Application for Plan Review

OVERHUS DINING ROOM ADDITION

Fire Marshal Division

**Re: Overhills Dinning Hall Addition
2495 Ray Road
Spring Lake, NC 28390**

101.1 FLOOR PLAN: CAFETERIA ADDITION
SCALE: 1/8" = 1'-0"

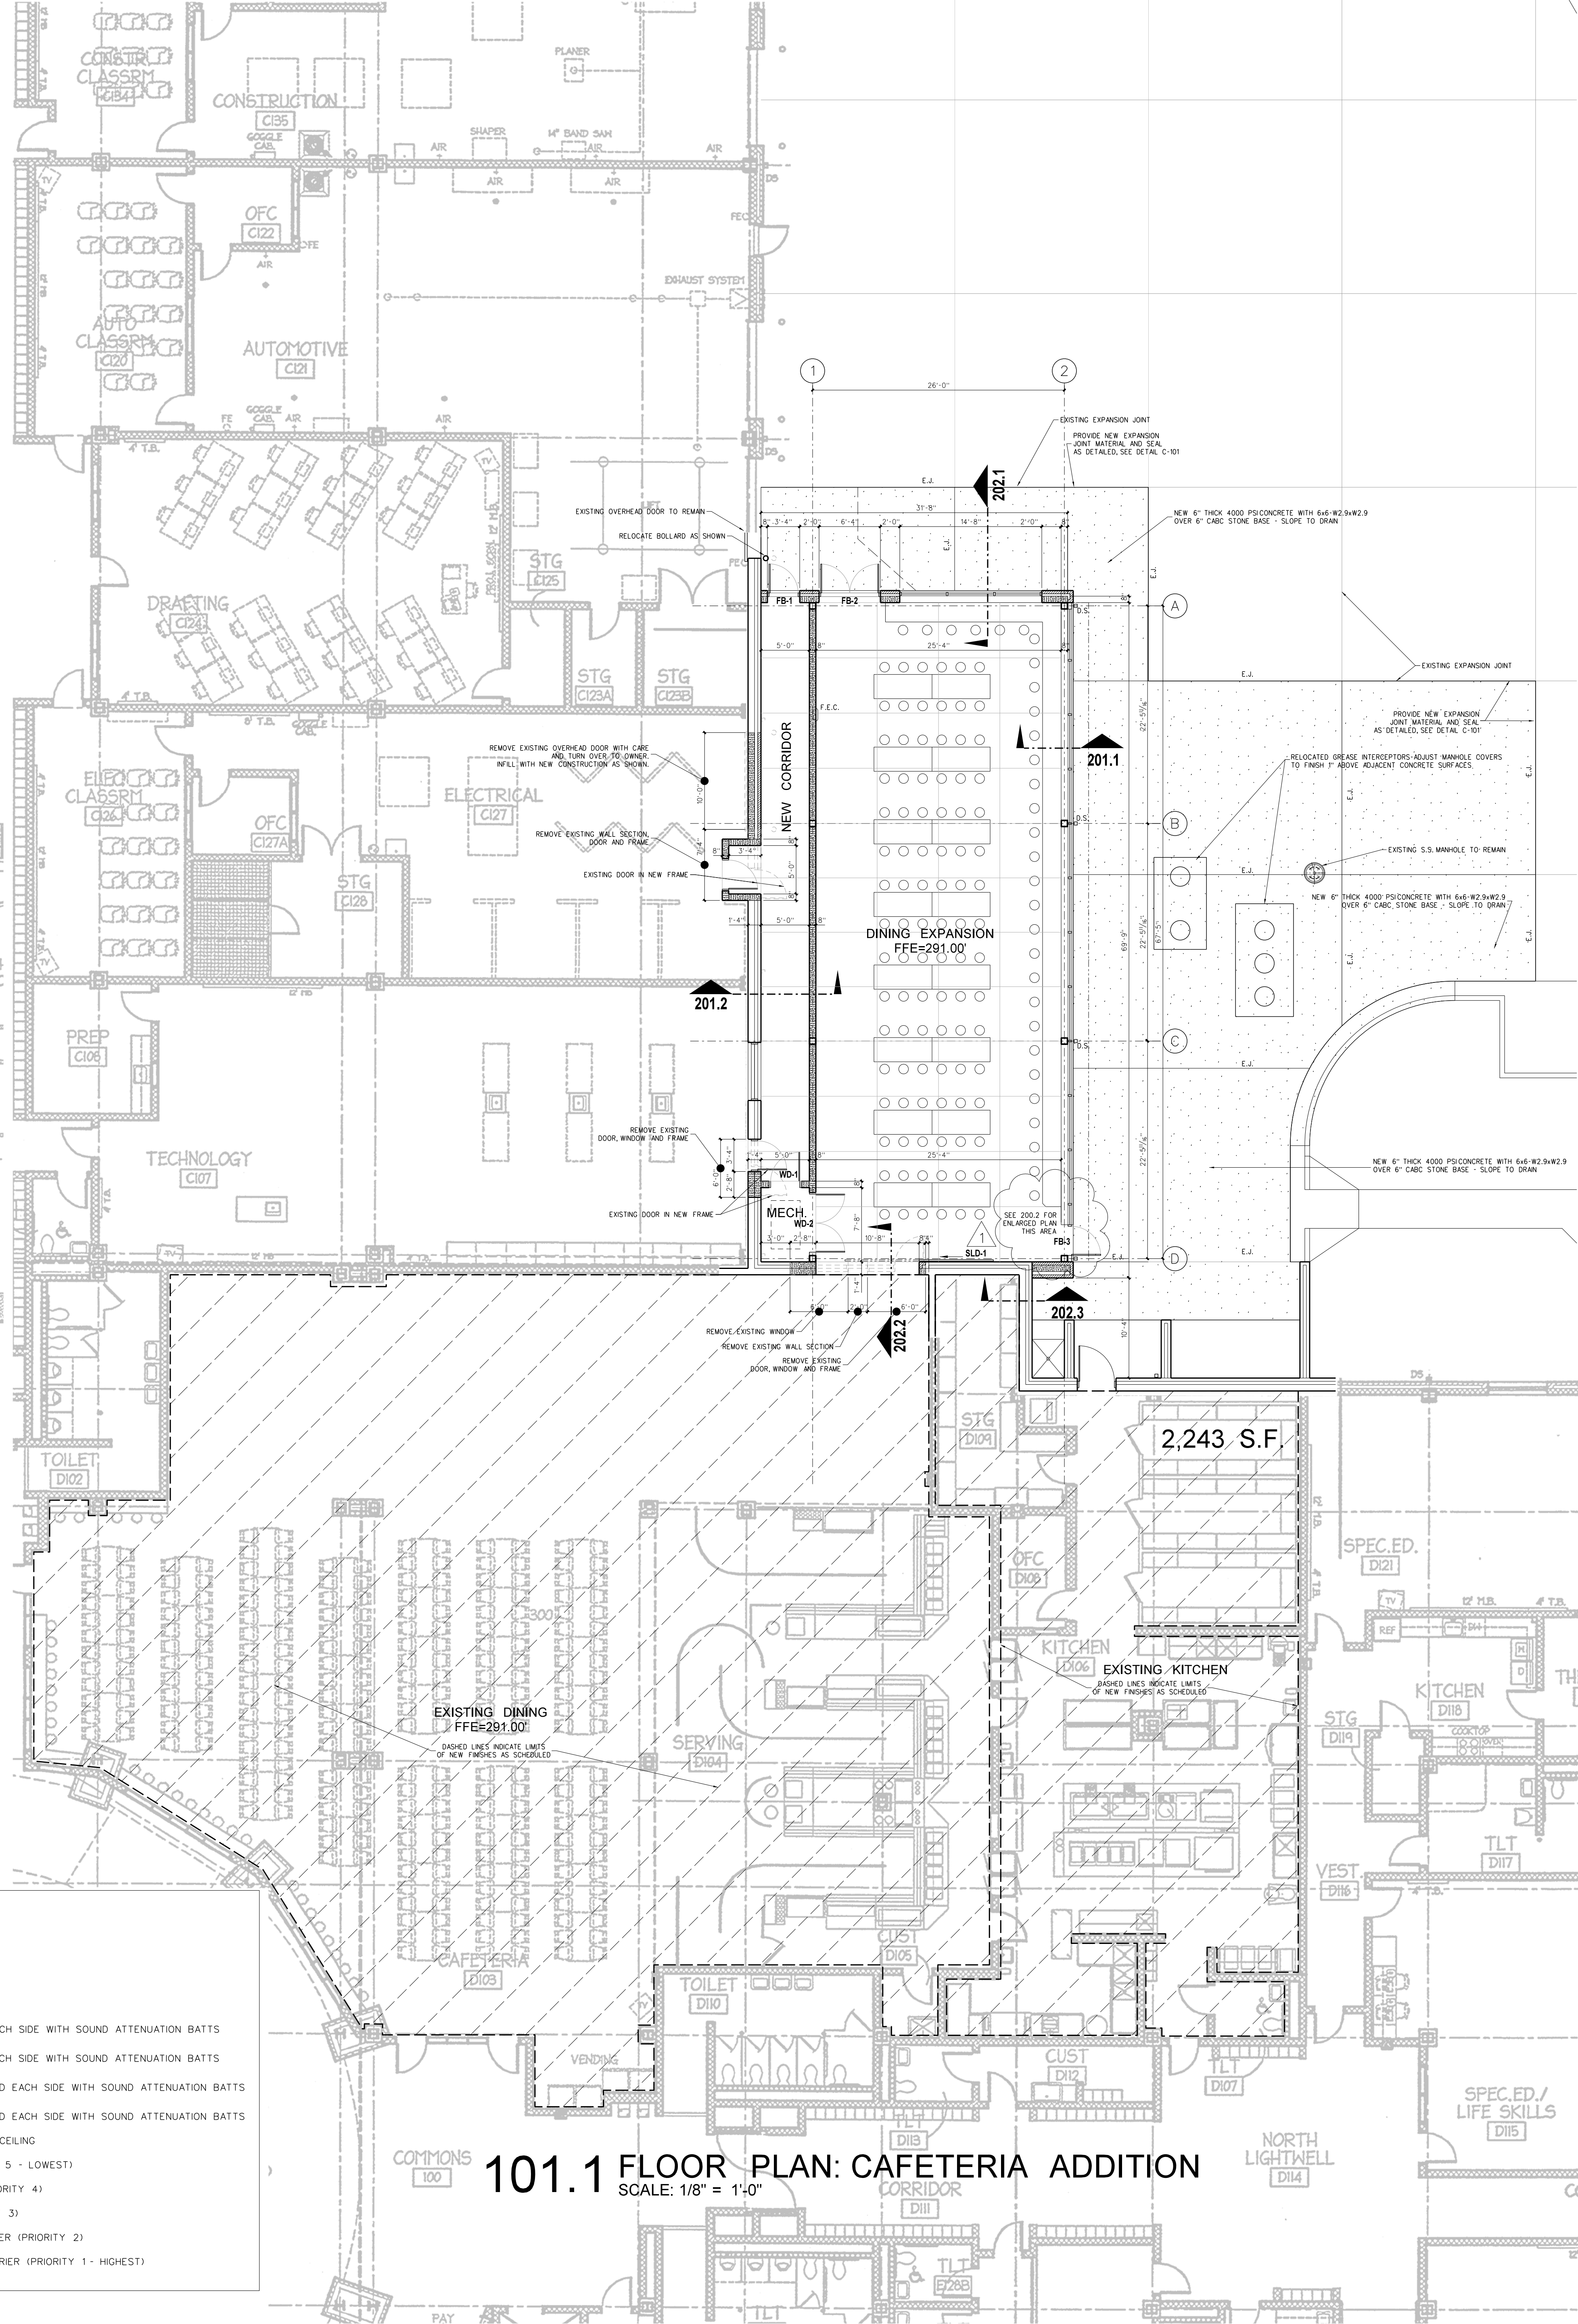
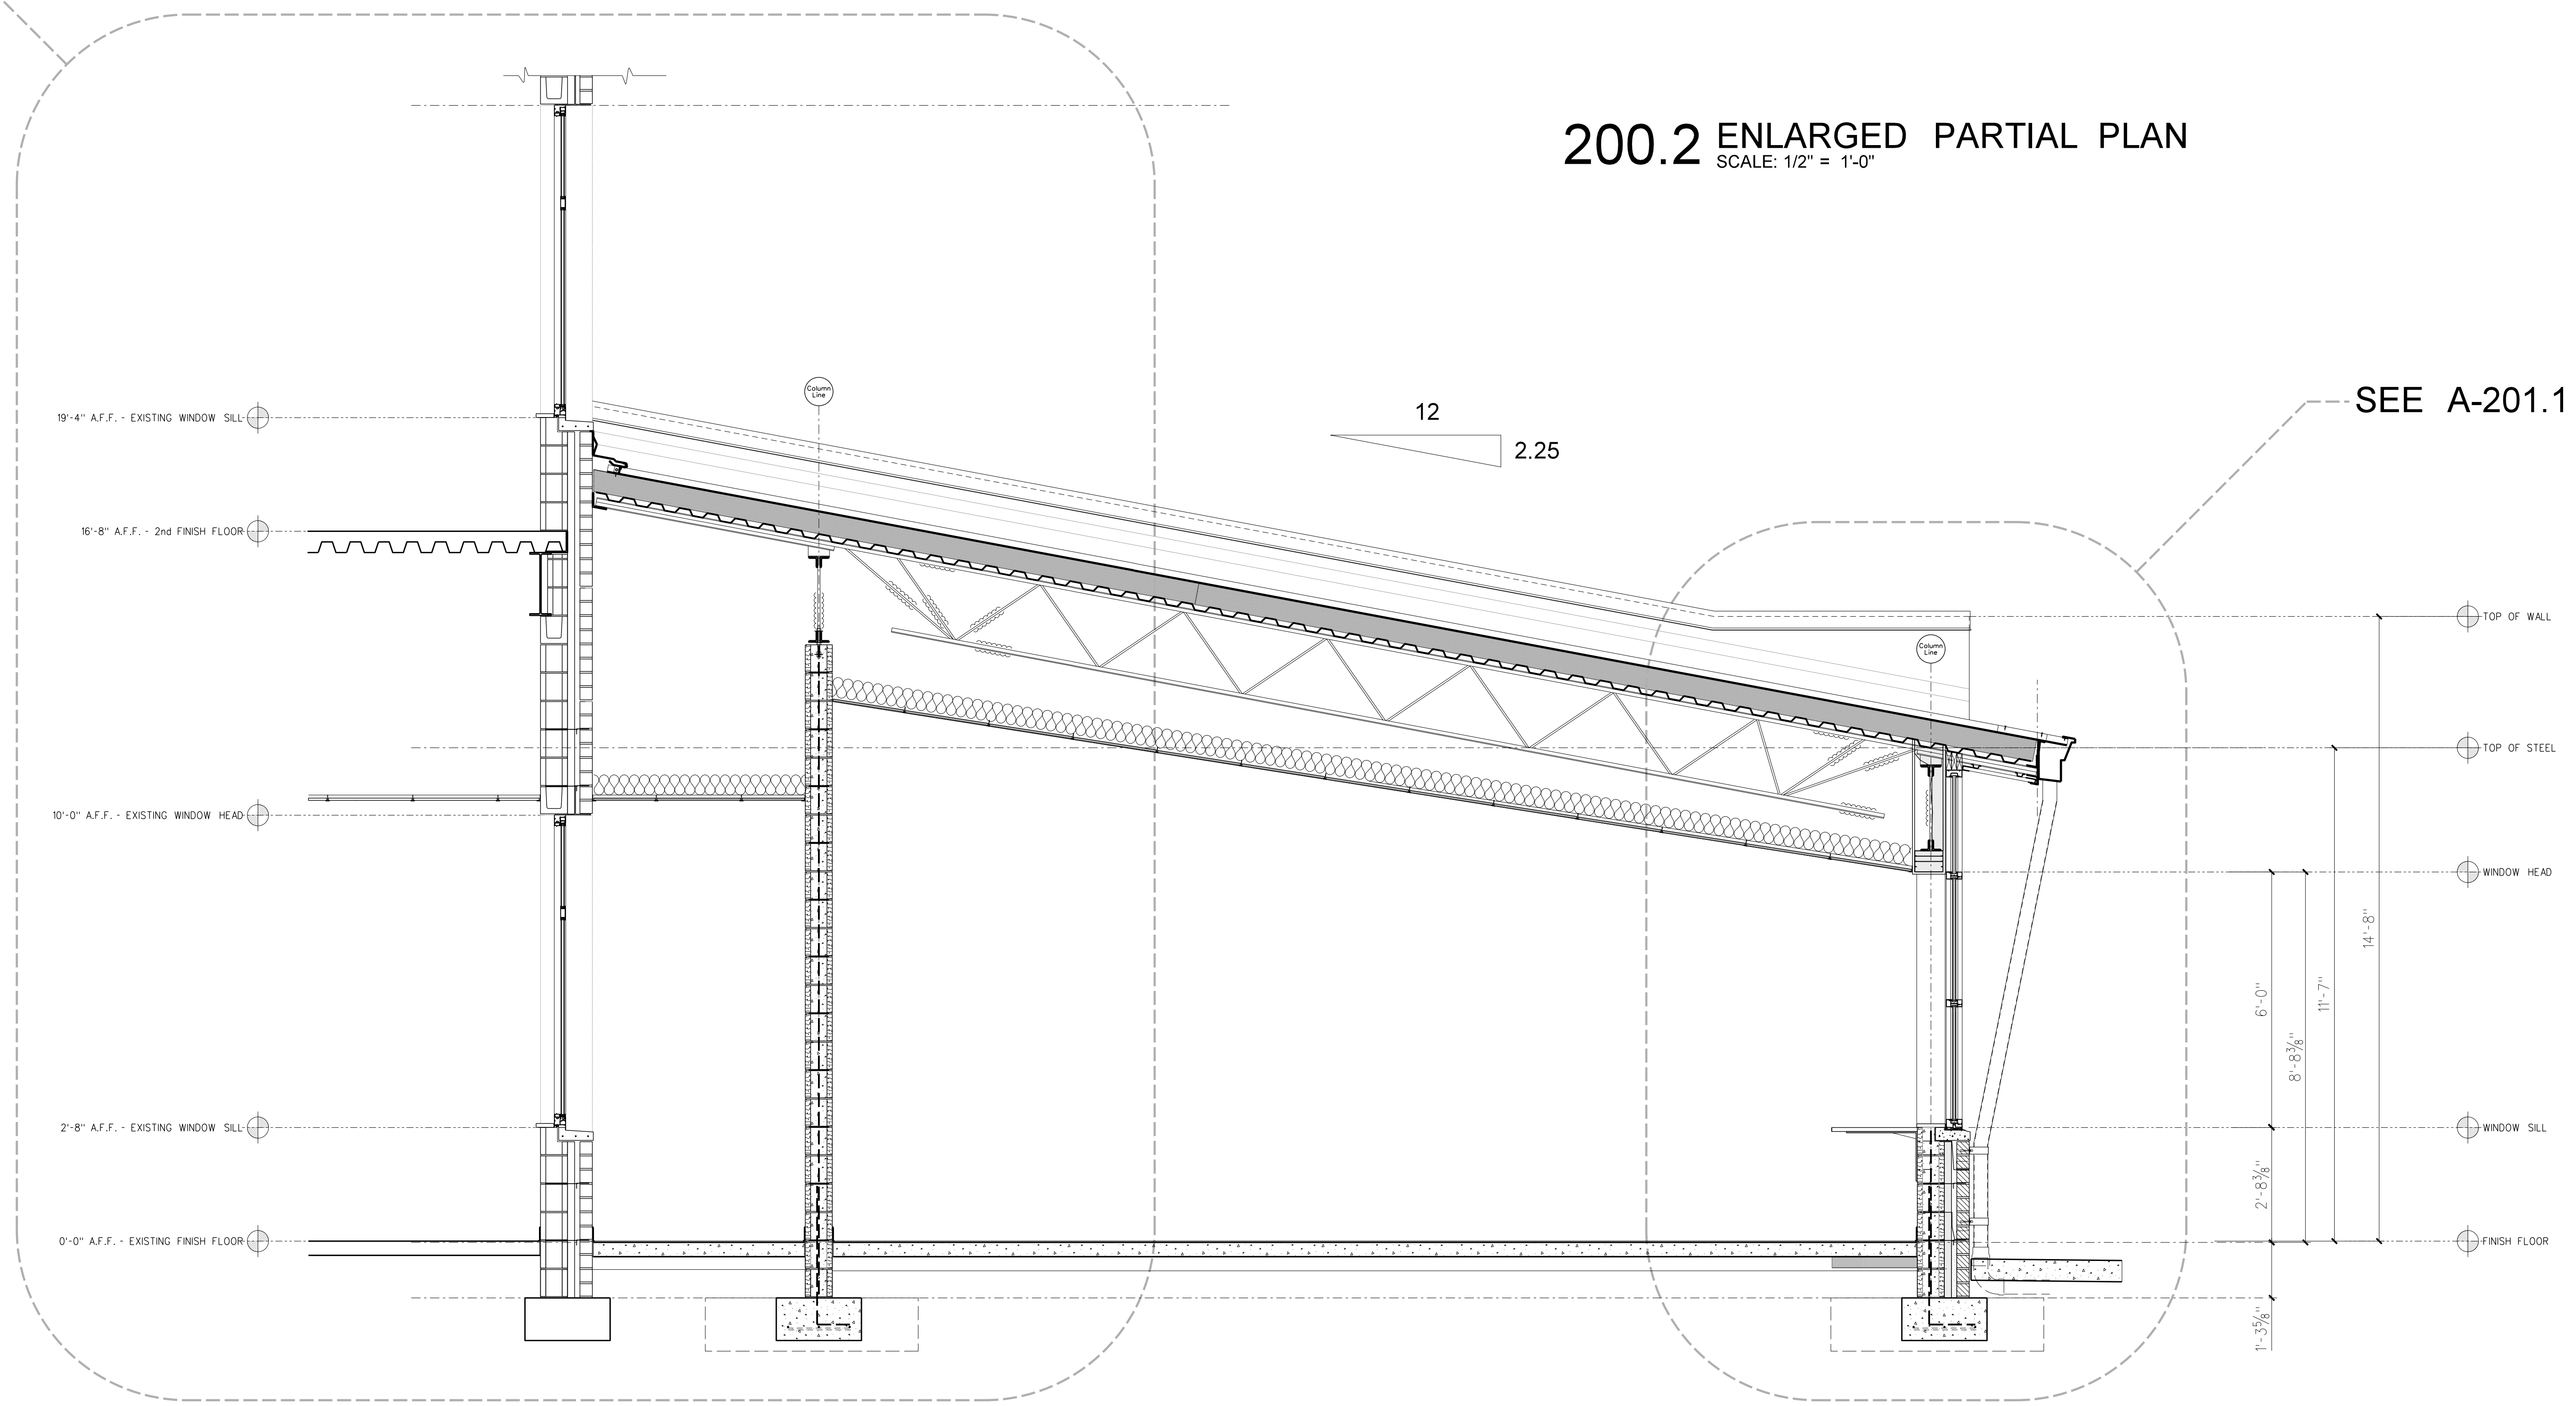
No.	Date	Revision
1	4/24/18	ADDED DOOR FE-3
